<b>Title - Sujet</b> Cell Upgrade, Dorchester Pen., N.B.	
<b>Solicitation No. - N° de l'invitation</b> EC016-140237/A	<b>Amendment No. - N° modif.</b> 002
<b>Client Reference No. - N° de référence du client</b> R.043937.001	<b>Date</b> 2013-06-10
<b>GETS Reference No. - N° de référence de SEAG</b> PW-\$PWB-004-3256	
<b>File No. - N° de dossier</b> PWB-3-36011 (004)	<b>CCC No./N° CCC - FMS No./N° VME</b>
<b>Solicitation Closes - L'invitation prend fin at - à 02:00 PM on - le 2013-06-13</b>	<b>Time Zone</b> Fuseau horaire Atlantic Daylight Saving Time ADT
<b>F.O.B. - F.A.B.</b> <b>Plant-Usine:</b> <input type="checkbox"/> <b>Destination:</b> <input type="checkbox"/> <b>Other-Autre:</b> <input type="checkbox"/>	
<b>Address Enquiries to: - Adresser toutes questions à:</b> Doucet, Gisele PWB	<b>Buyer Id - Id de l'acheteur</b> pwb004
<b>Telephone No. - N° de téléphone</b> (506) 636-4541 ( )	<b>FAX No. - N° de FAX</b> (506) 636-4376

This Tender Amendment No. Two (2) is raised to include the following revisions.

Addendum No. 2.

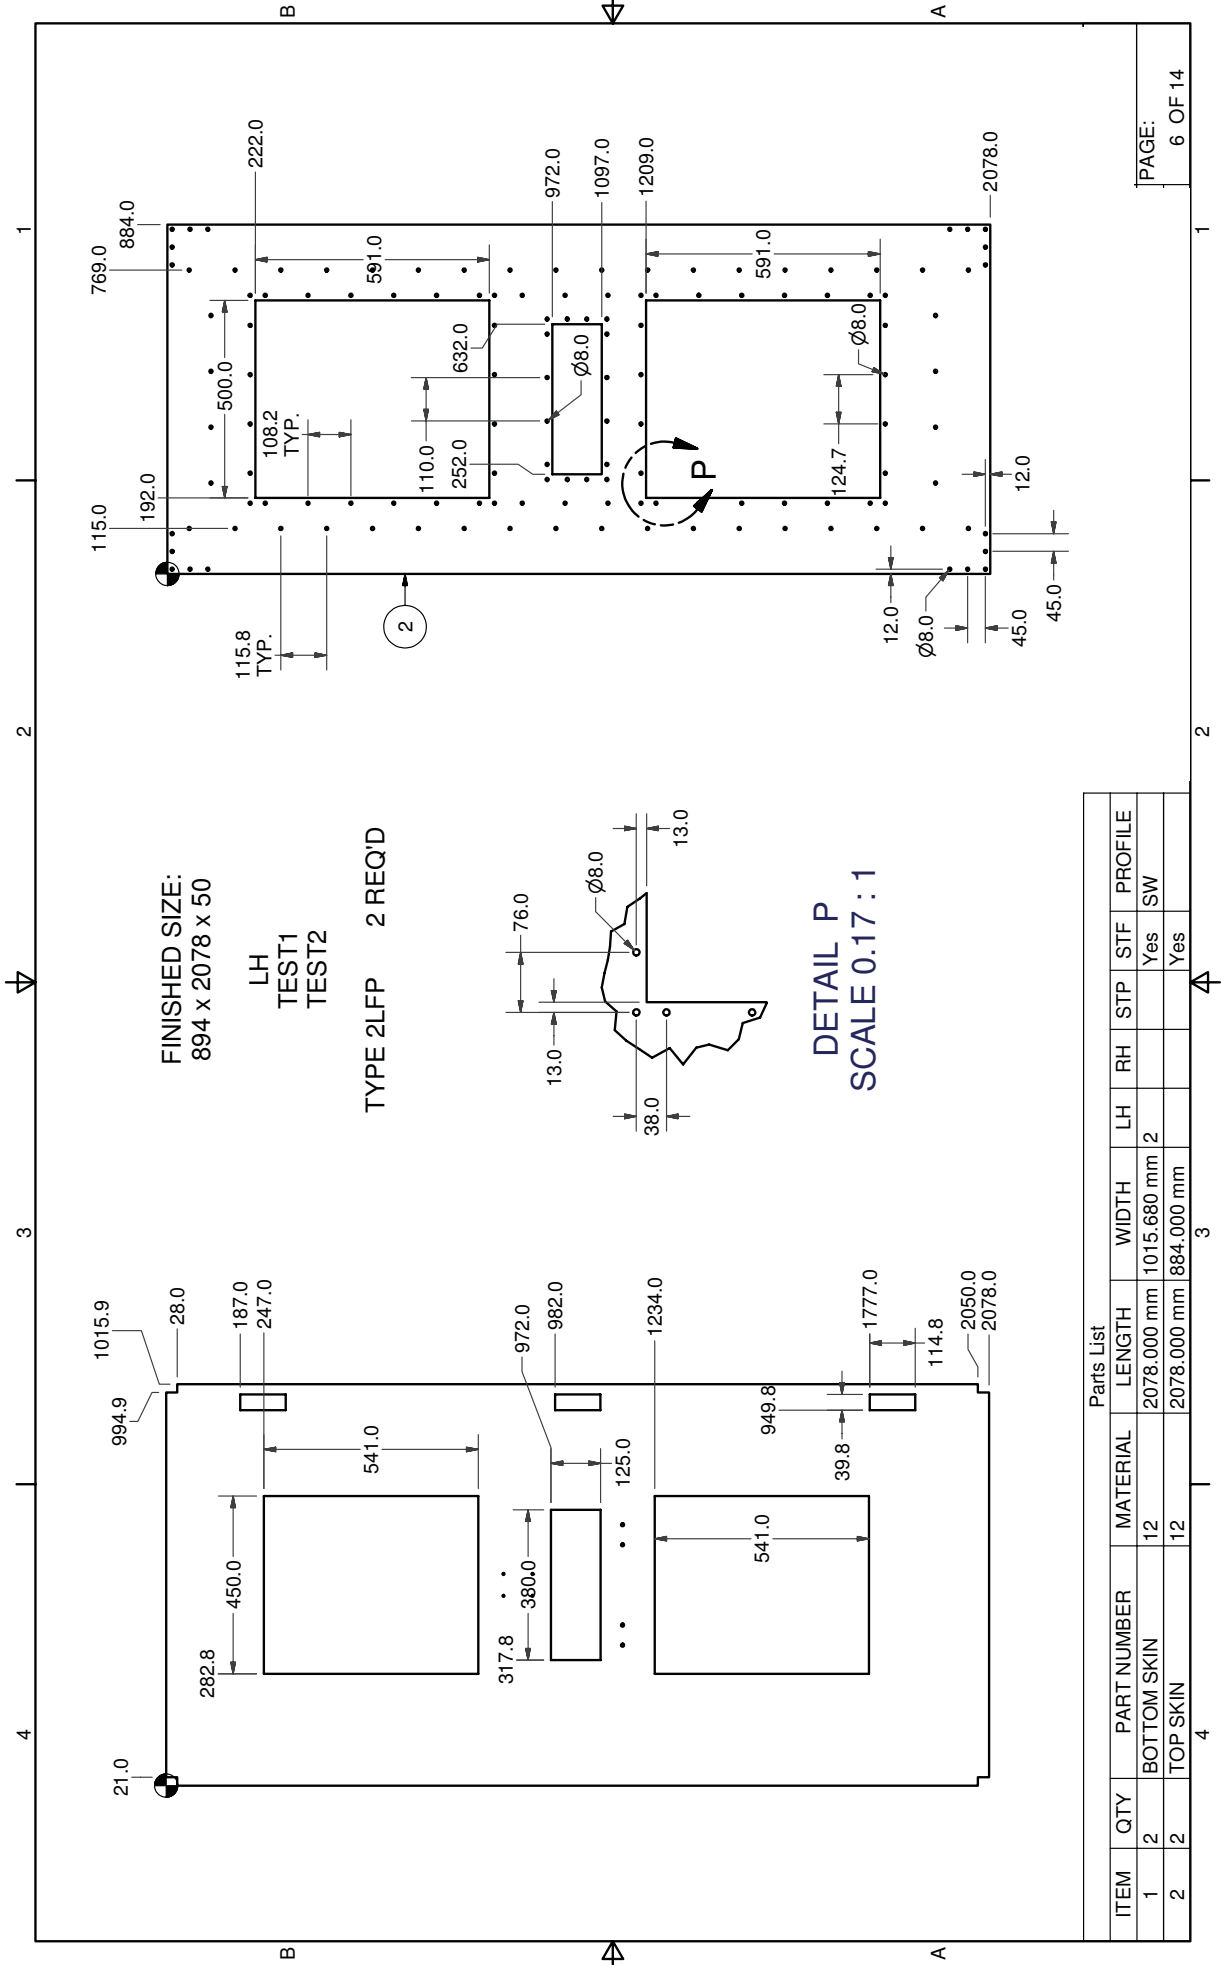
Construct the observation doors (D252, D254) following CSC's "Prototype Cell Door Development" drawings (Attached).
